Office Action Summary	Application No. 10/575,191	Applicant(s) WADA, SHIZUO	
	Examiner FANNIE KEE	Art Unit 3679

DETAILED ACTION

17. Claims 1-5 are rejected under 35 U.S.C. 102(b) as being anticipated by Stahn et al European Patent Application No. EP 1,236,946 A1.

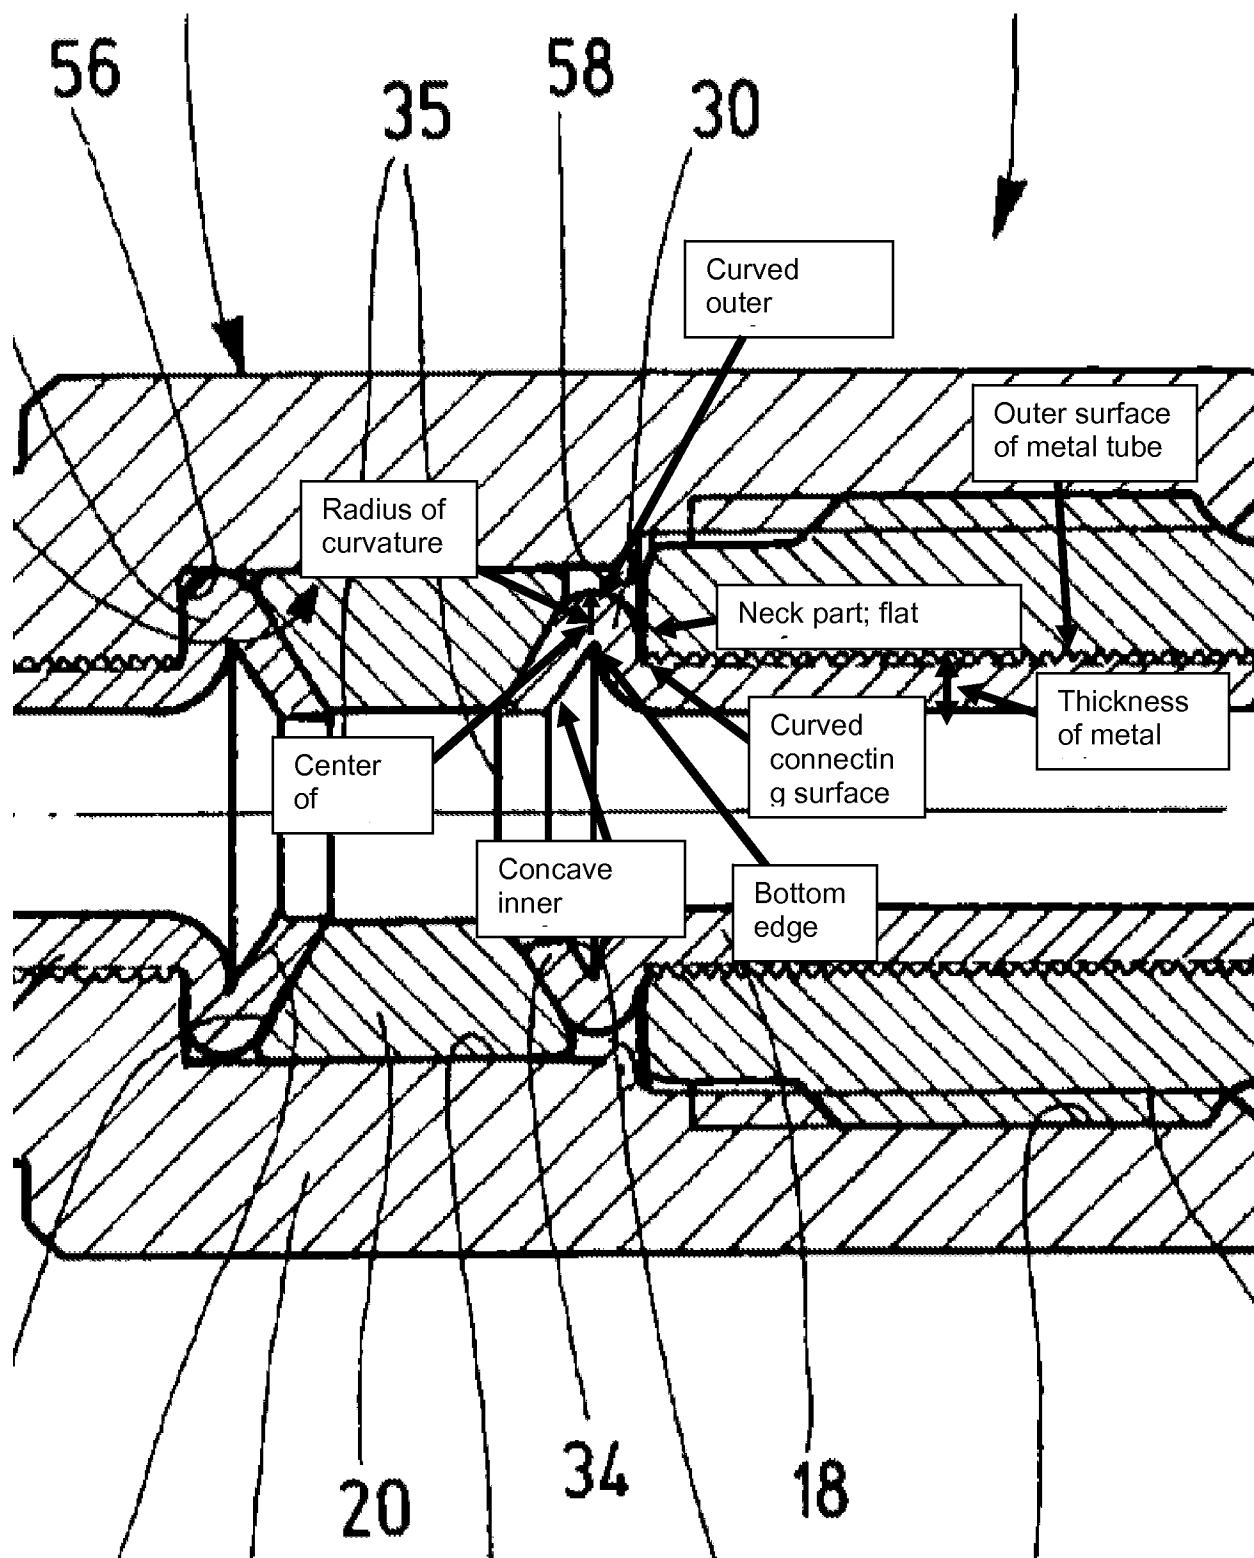
With regard to claim 1, and as seen in the figure below, Stahn et al disclose a flared end structure of a metal tube to be pressed against a seat formed in a member by tightening a coupling nut to the member, said flared end structure having a joining end part **(34)** to be pressed against the seat of the member, and a curved part **(30)** continuous with the joining end part;

wherein the curved part **(30)** has a curved outer surface and a concave inner surface having a bottom edge, and

the curved outer surface has a radius R of curvature smaller than a wall thickness t of the metal tube.

With regard to claim 2, and as shown in the figure above, Stahn et al disclose a flared end structure of a metal tube to be pressed against a seat formed in a member by tightening a coupling nut to the member having a joining end part **(34)** to be pressed against the seat of the member, and a curved part **(30)** continuous with the joining end part;

wherein the curved part **(30)** has a curved outer surface and a concave inner surface having a bottom edge, and

the curved outer surface has a center of curvature at a position on the radially outer side of the bottom edge of the concave inner surface.

With regard to claim 3, and as shown in the figure above, Stahn et al disclose the curved outer surface merging into a flat surface, on which the coupling nut exert pressure, of a neck part, and the bottom edge of the concave inner surface is in a radial range corresponding to the flat surface of the neck part.

With regard to claim 4, and as shown in the figure above, Stahn et al disclose the flat surface of the neck part being perpendicular to the axis of the tube.

With regard to claim 5, and as shown in the figure above, Stahn et al disclose the flat surface of the neck part being connected to the outer surface of the metal tube by a curved connecting surface having a center of curvature at a position radially outside the

metal tube, and the flat surface extends between the curved surface of the curved part and the curved connecting surface.

With regard to claim 8, and as shown in the figure above, Stahn et al disclose the flat surface of the neck part extending between the curved outer surface and the curved connecting surface.
